Addendum No. 2

Subject: Henry Lawton School Classroom Modernization Renovation
SDP Contract Nos. 2022-007-G, 2022-007-P, 2022-007-E

Location: Henry W. Lawton School
4501 Benner Street
Philadelphia, Pennsylvania 19135

This Addendum, dated 17 of February, 2022, shall modify and become part of the Contract Documents for the work of this project. Any items not mentioned herein, or affected by, shall be performed strictly in accordance with the original documents.

1 LIGHTING PLAN - 1ST LEVEL - PARTIAL ZONE 'A'
 E-110 SCALE: 1/8" = 1'-0"

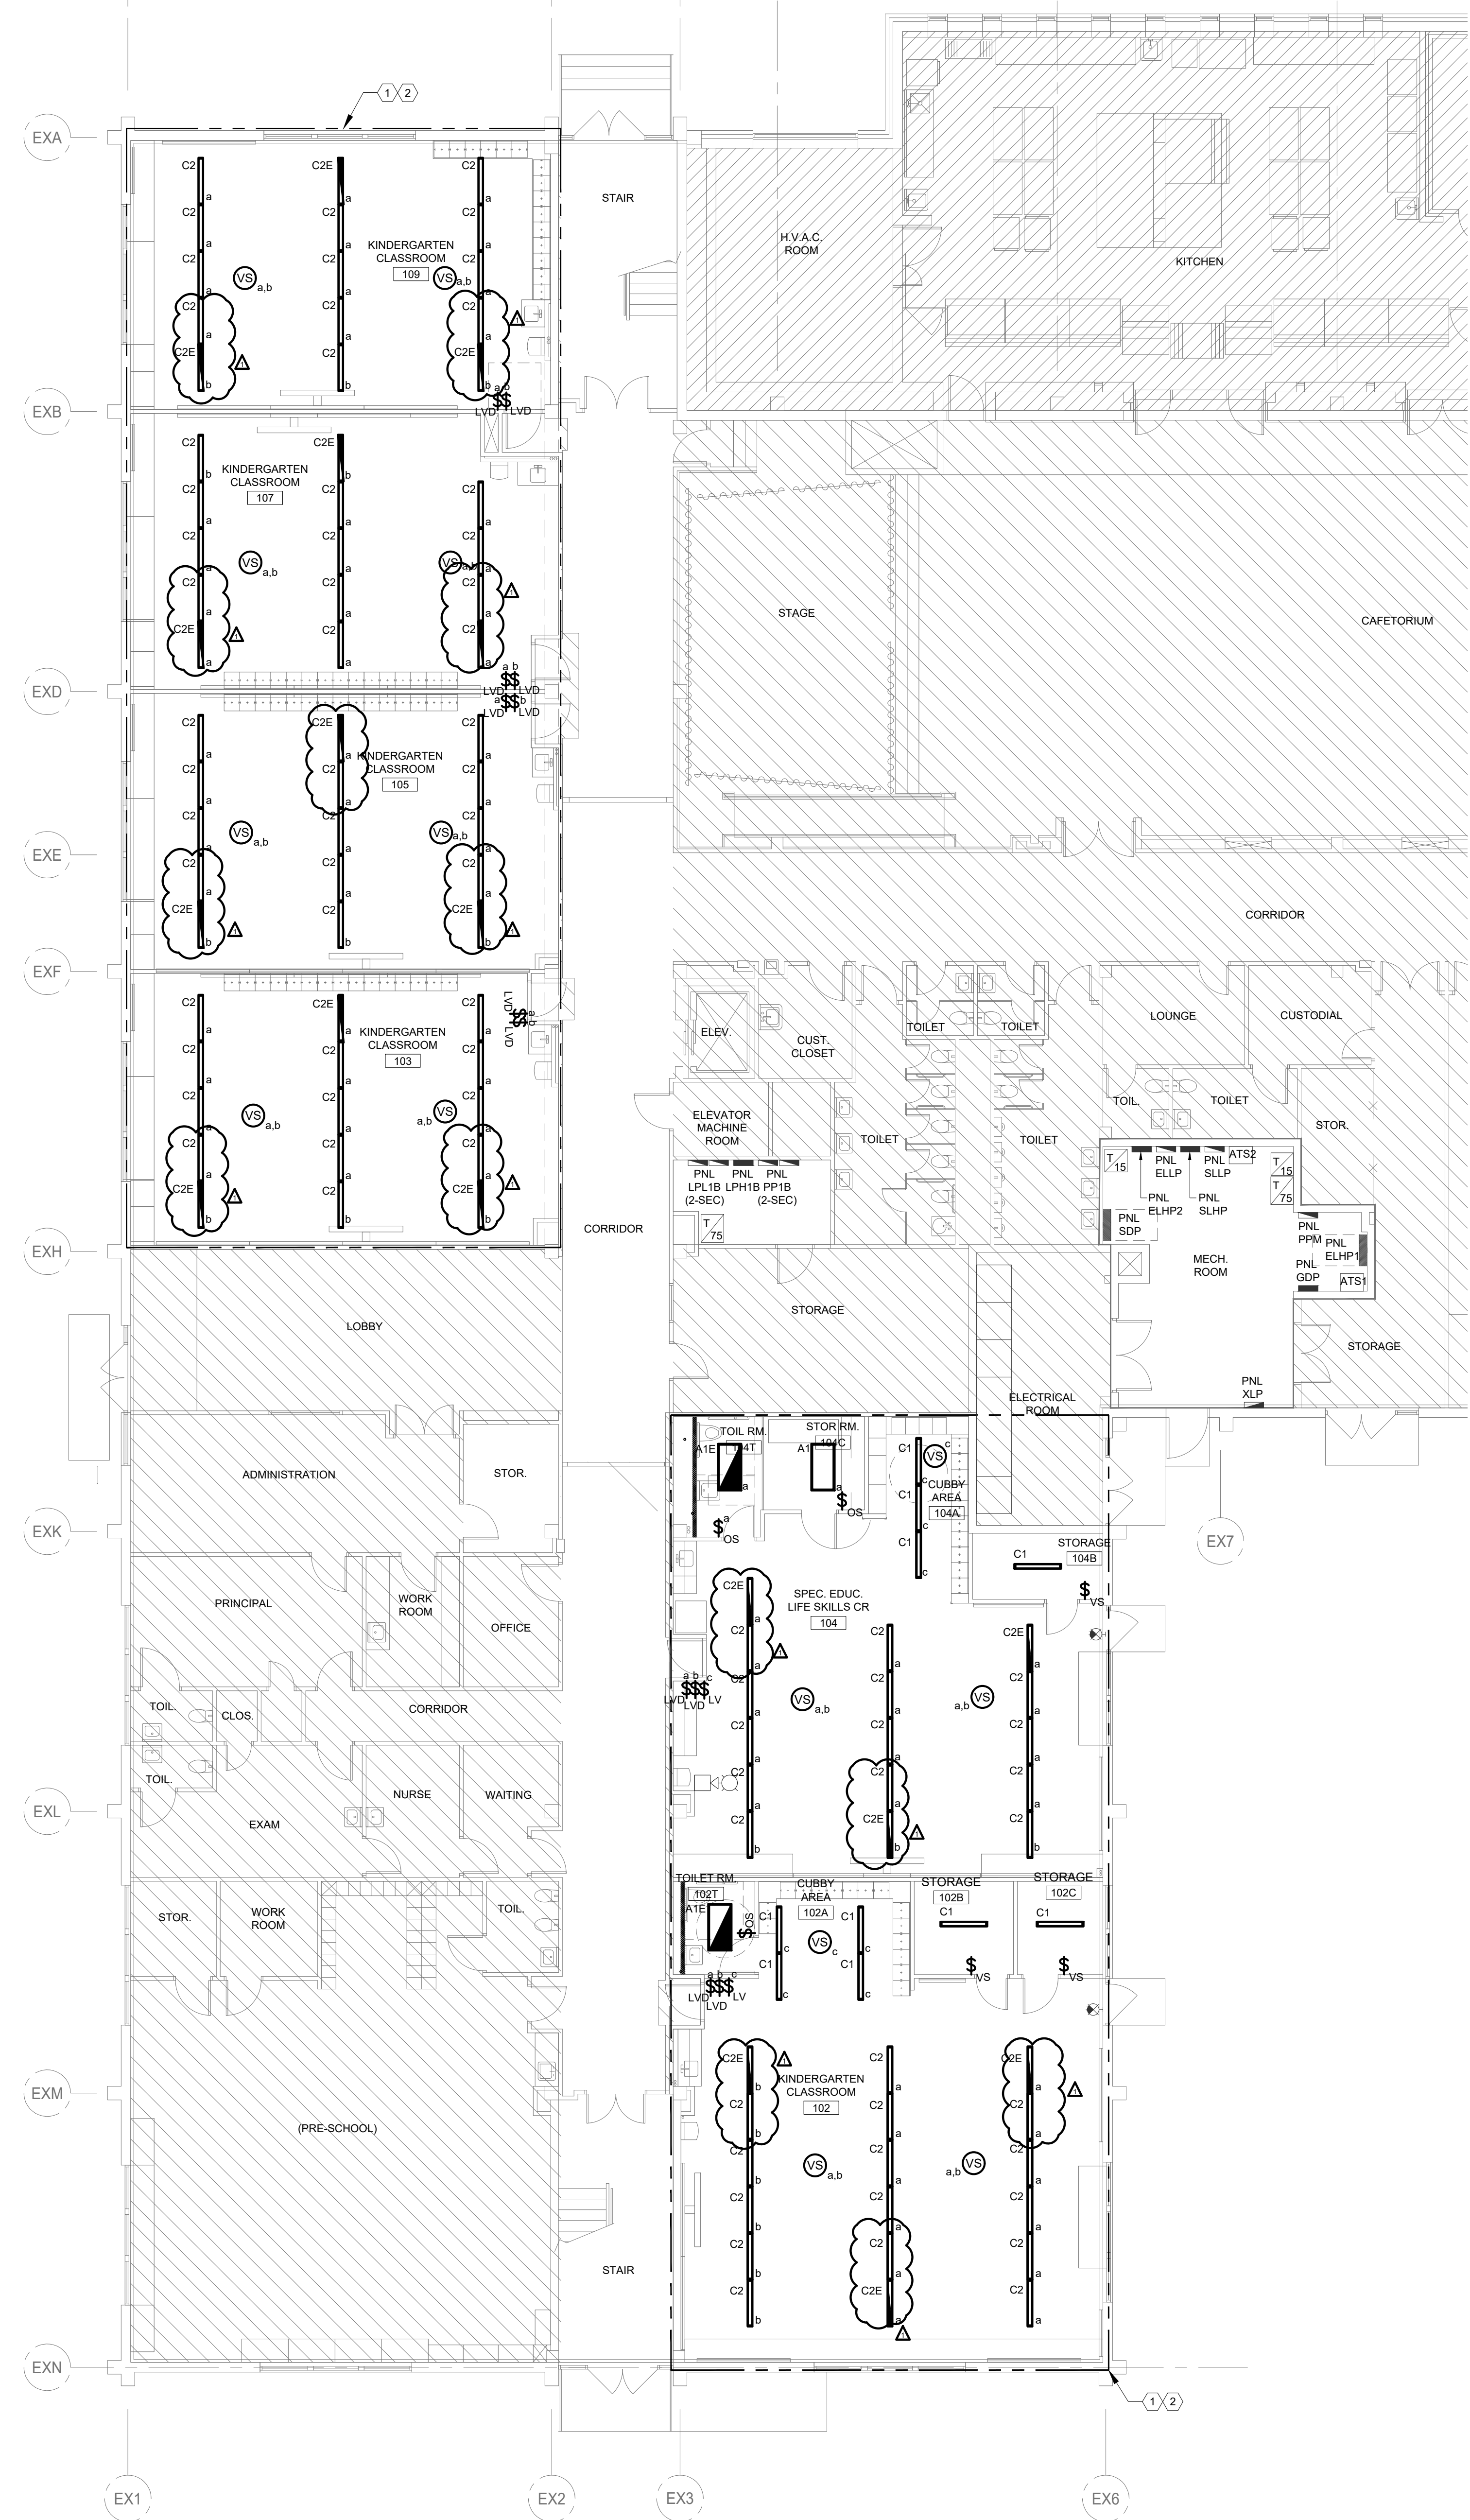
1. MODIFY General notes as indicated on drawings.
2. MODIFY Detail 1 as indicated on drawings

Question 17: Fixture types C2 and C2E on drawing E-110 are specified as 4' standalone fixtures. Please confirm the runs should be specified as 20 ft and 24 ft continuous runs where the manufacturer would provide (5) 4ft or (6) 4ft sections respectively joined together.

Question 18: Drawing E-110 shows continuous runs of fixture types C2 & C2E. Based on the current design of where the emergency section lands in the run, the normal and emergency circuit will have to travel together between each fixture section because there is an existing concrete ceiling. The emergency fixture is within the middle of the run so we cannot access the side of the fixture to enter the emergency branch circuit conduit. Is this NEC/UL compliant to have the normal and emergency circuits travel through the fixtures together? If the answer is no, can this drawing be adjusted to show the emergency circuit on the ends of the runs so the normal and emergency branch circuits can be separated?

Question 19: Fixture type C1 on drawing E-110 is specified as a 4' standalone fixture. There is one instance in Cubby Area 104A where there are (3) C1's shown in a row. Please confirm this run should be specified as a 12' continuous run where the manufacturer would provide (3) 4ft sections joined together.

Answer 17: Confirmed

Answer 18: Yes – drawing E-110 will be updated to show emergency fixtures at the end of the run.

Answer 19: Confirmed

1 POWER PLAN - 1ST LEVEL - PARTIAL ZONE 'A'
E-120 SCALE: 1/8" = 1'-0"

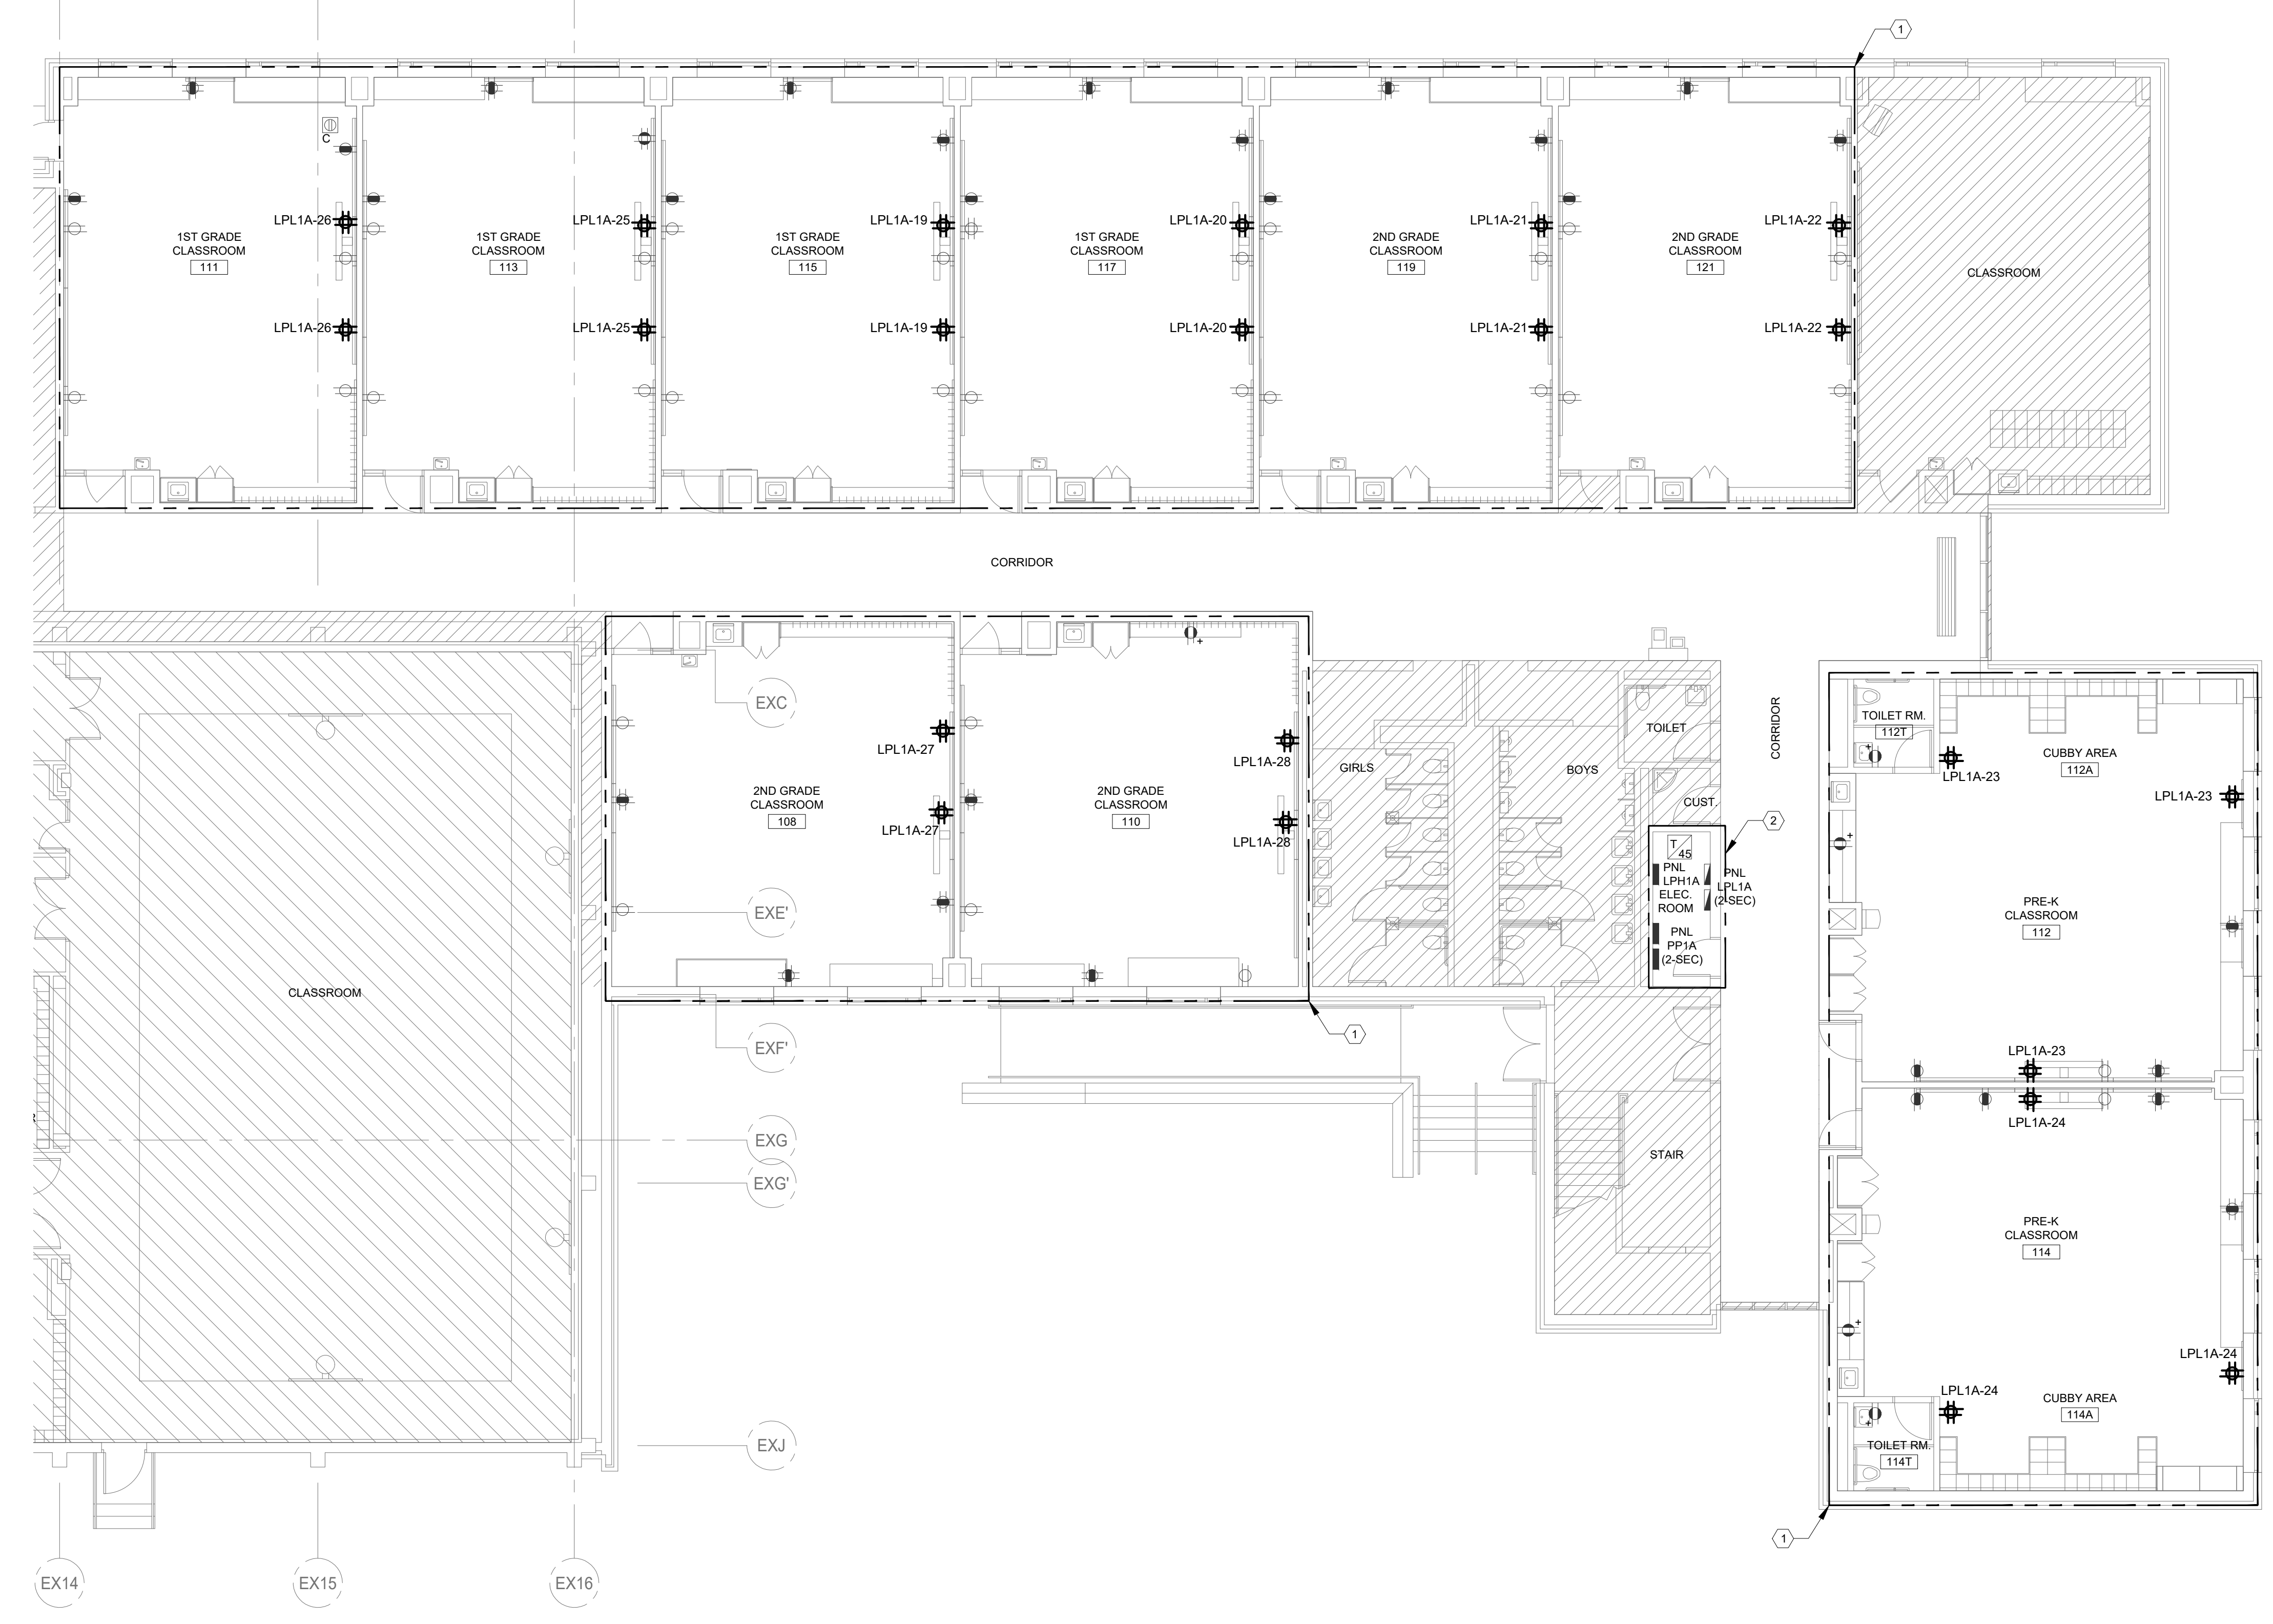
1. MODIFY General notes as indicated on drawings.
2. MODIFY Sheet notes as indicated on drawings.

Question 8: Drawings E-120, E-121 & E-122 keynote #1 calls for all receptacles to be tamper resistant AFCI. Spec section 262726 neither specifies duplex tamper resistant AFCI receptacles nor does it specify duplex tamper resistant combination GFCI/AFCI receptacles. Please clarify design intent.

Answer 8: Provide tamper resistant receptacles – AFCI not required.
